**WETLANDS REVIEW BOARD  
REGULAR MEETING**

## **MEMORANDUM**

**SUBJECT:** Minor subdivision of one lot into nine lots

**PLAT OF THATCHER SUBDIVISION**  
 A SUBDIVISION OF TRACT A1  
 SOUTH LENA SUBDIVISION  
 CITY AND BOROUGH OF JUNEAU, ALASKA  
 JUNEAU RECORDING DISTRICT

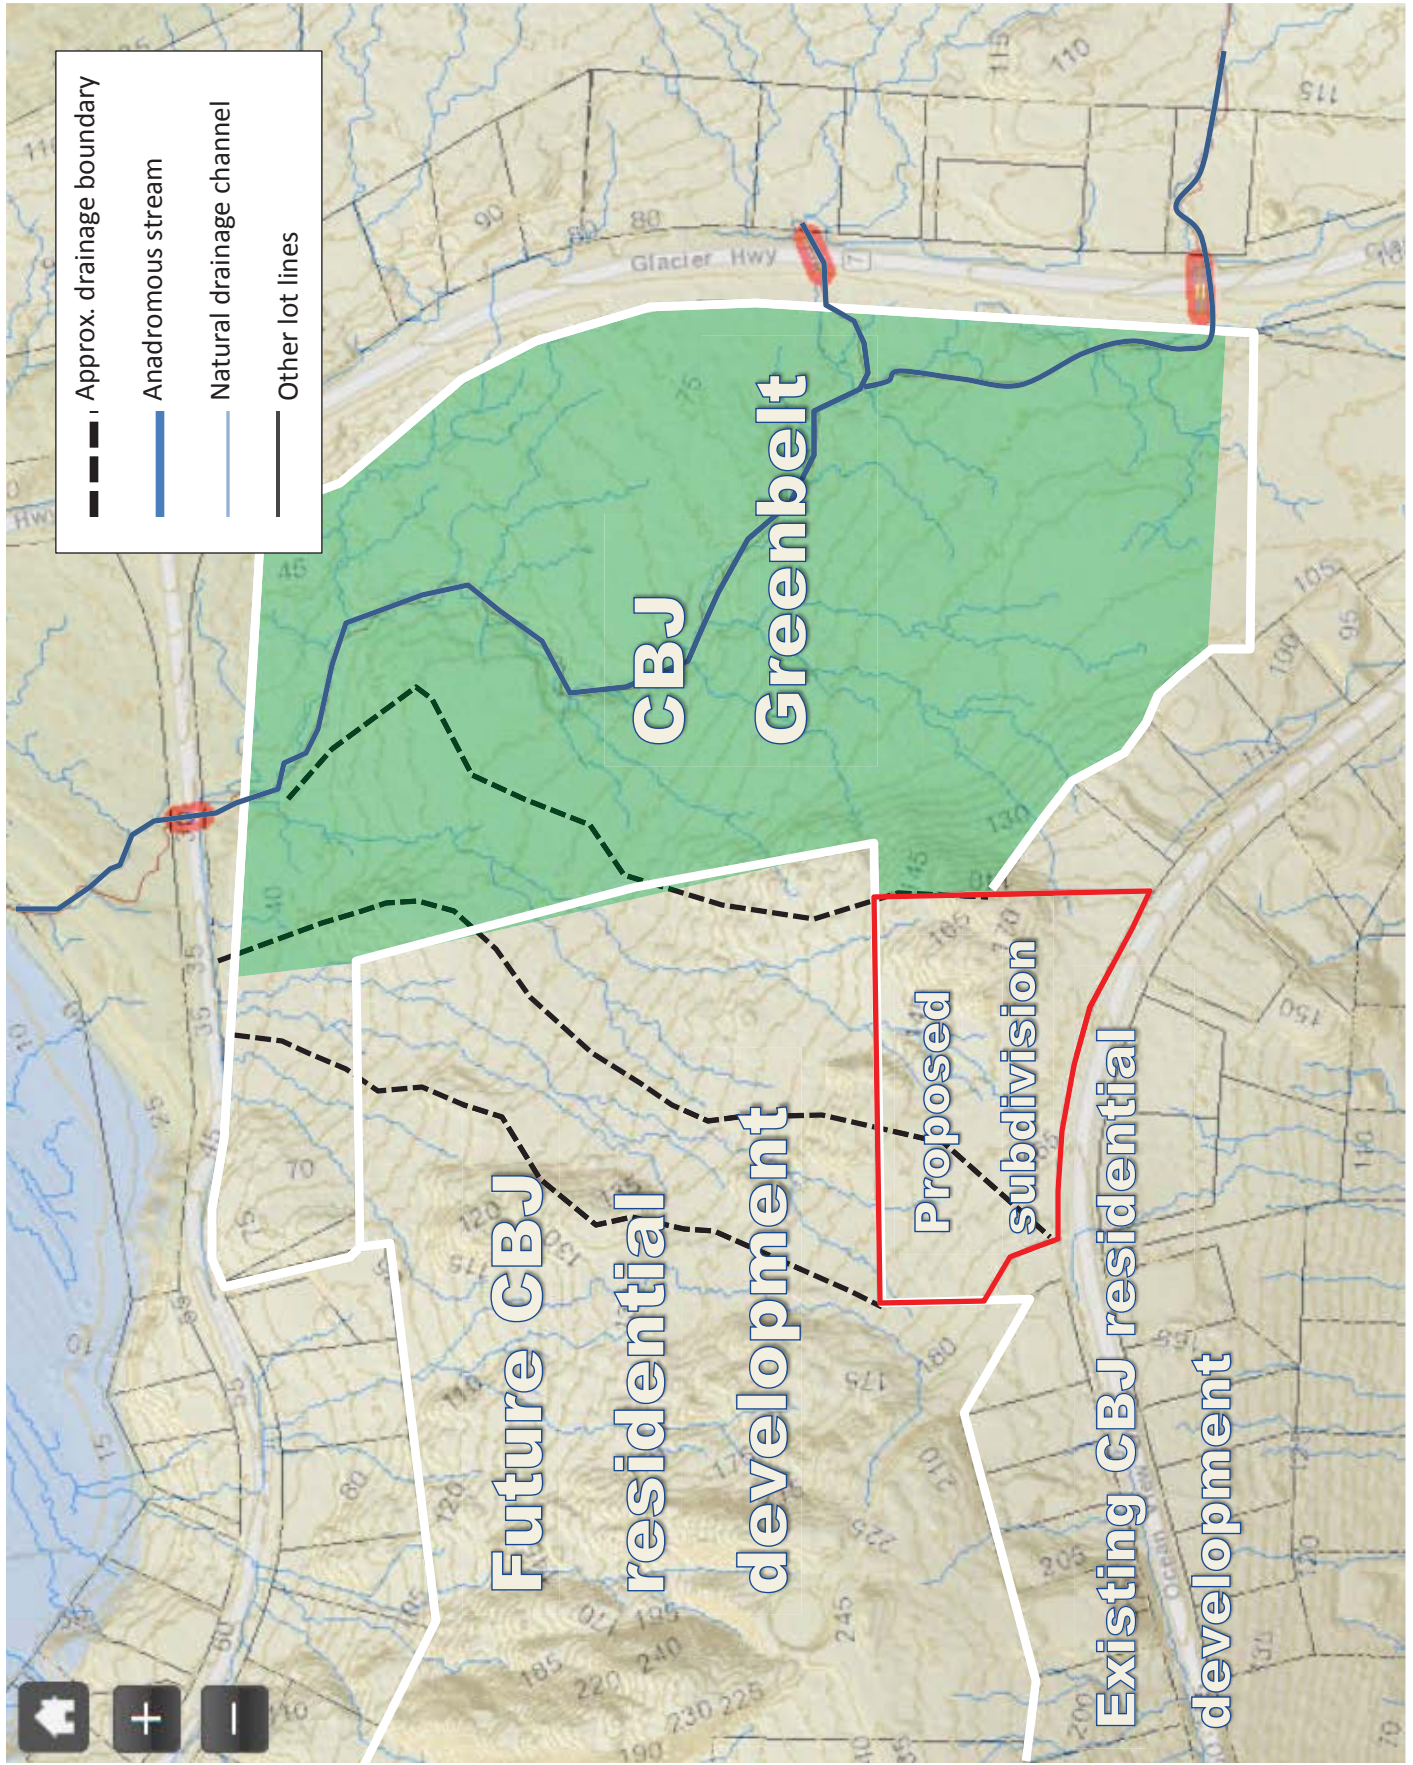
A number of drainage plans have been suggested to date, and these will have implications for wetlands on CBJ lots. The applicants have proposed sheet flow drainage across the subdivision toward the neighboring CBJ lot. However, CBJ Lands Division has concerns that should they develop their adjacent parcel, the additional surface runoff from the subject subdivision would add additional cost to the CBJ drainage plan.

CBJ Lands Division would prefer that surface water drainage be diverted away from its current natural drainage path either toward the CBJ greenbelt or to Ocean View Drive using a series of ditches and culverts. The latter suggestion would require a new culvert to be added under Ocean View Drive.

**WETLAND UNITS**

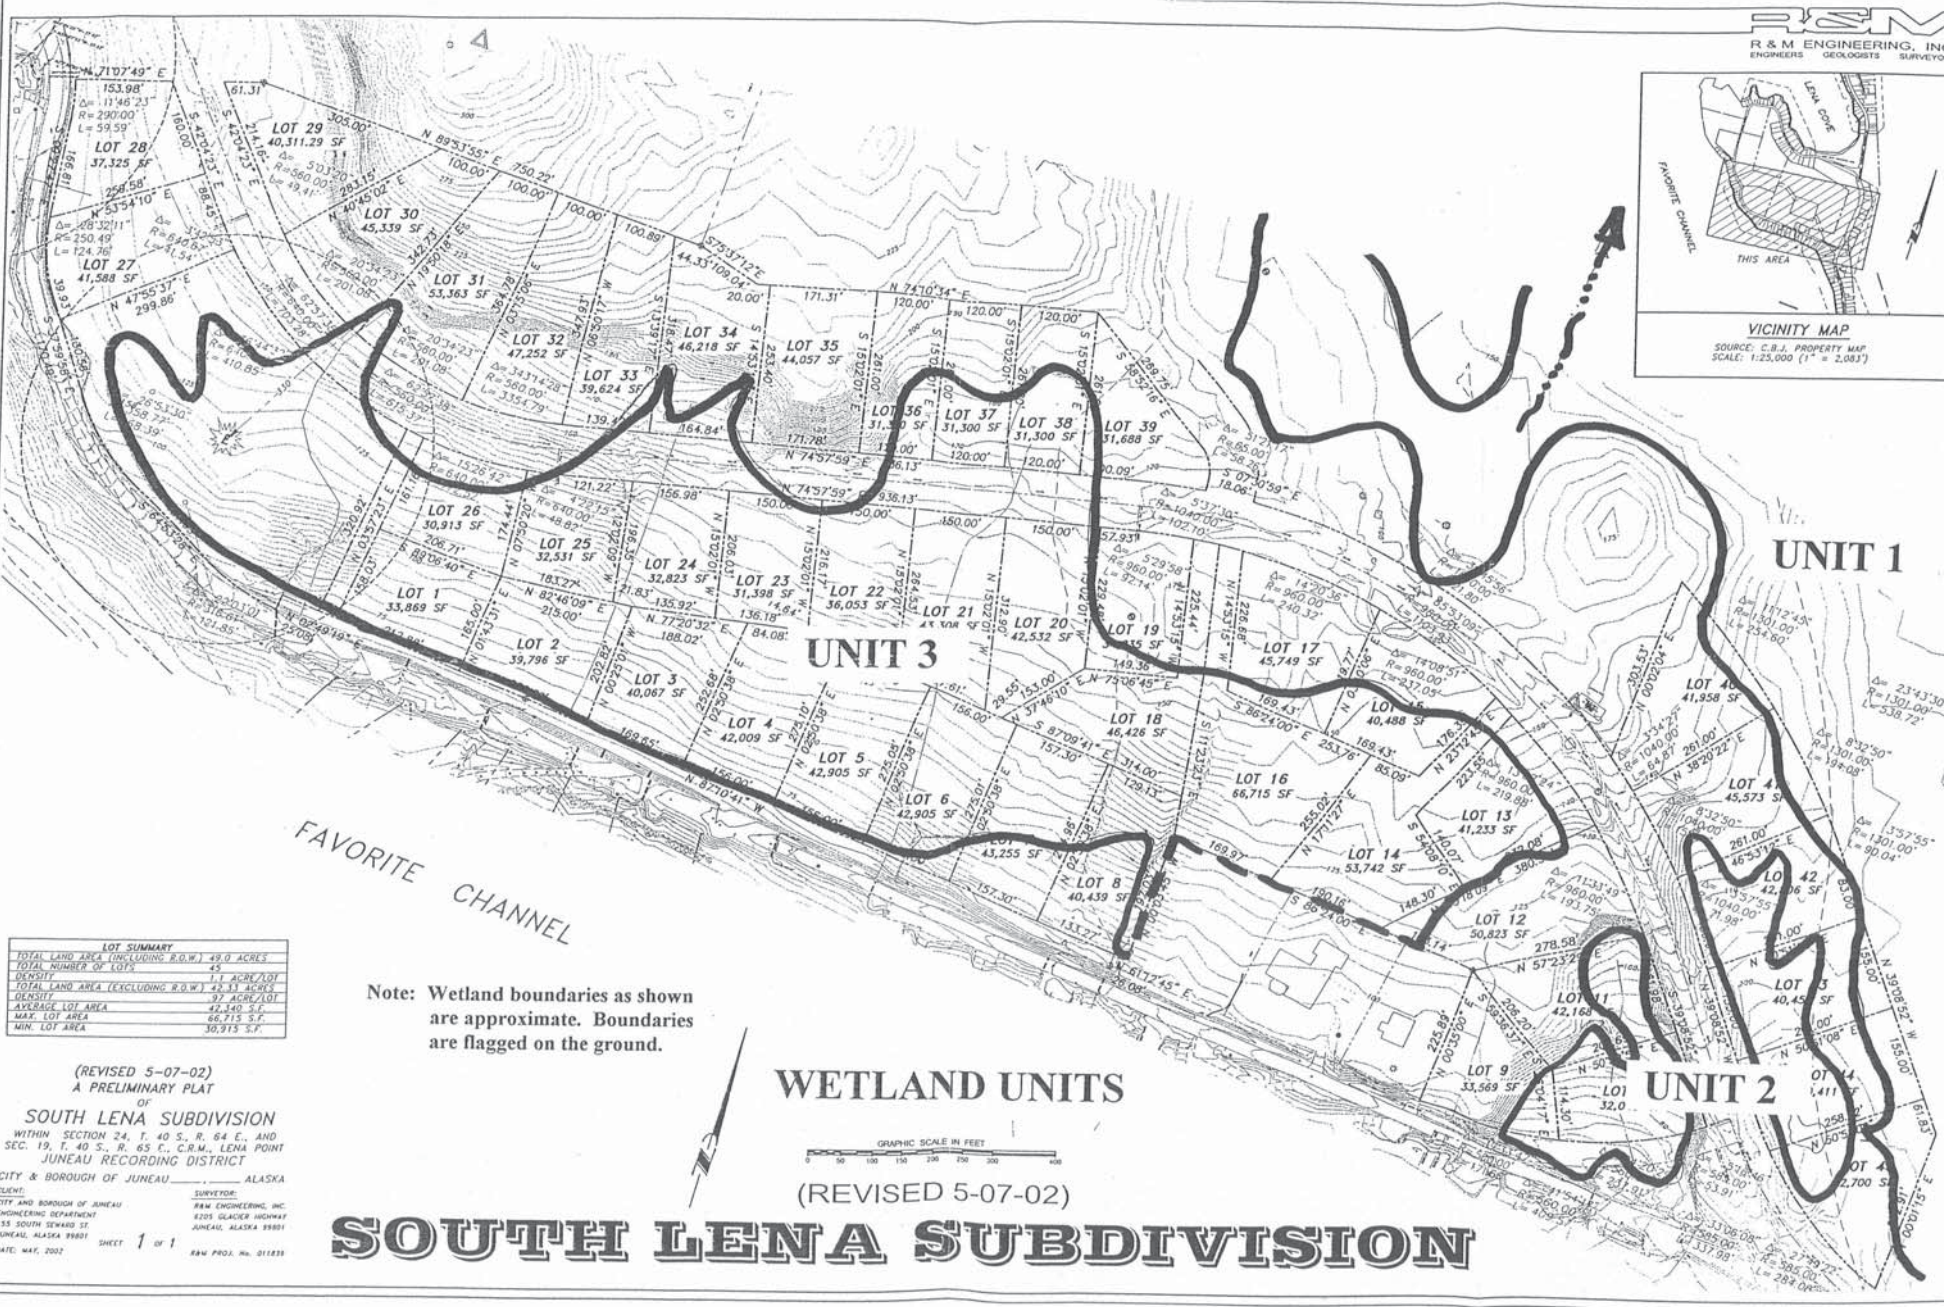
Because the Board is concerned about maintaining wetland functions, the integrity of stream drainages, and preventing flooding and erosion of downstream properties, we make the following recommendations concerning the South Lena Subdivision:

- 3) Remove Lots 1-6 from Block D to maintain functions of the muskeg meadow wetland that borders these lots and supplies waterflow to Picnic Creek. Because this wetland is fragile and sensitive to impacts from public use, development of these lots would reduce its function in maintaining flow and water quality in Picnic Creek. If this recommendation cannot be implemented by CBJ, the Board recommends a compromise that reduces the size of lots 1-5, by moving the property lines out of the wetlands; and fully removes lot 6 from consideration, since this lot will be too small to adequately develop without wetland encroachment.

- 4) Establish a maximum building pad size for each lot in Unit Three (Blocks A, B, and C), and prohibit development within the 25 foot rear yard setback. The forested wetlands in Unit Three function to attenuate storm flow and erosion, and extensive clearing of these lots could exacerbate the potential for windthrow and runoff in this Unit. This recommendation will serve to limit the amount of land clearing that can take place within the Unit, which will preserve wetland functions and drainage patterns.
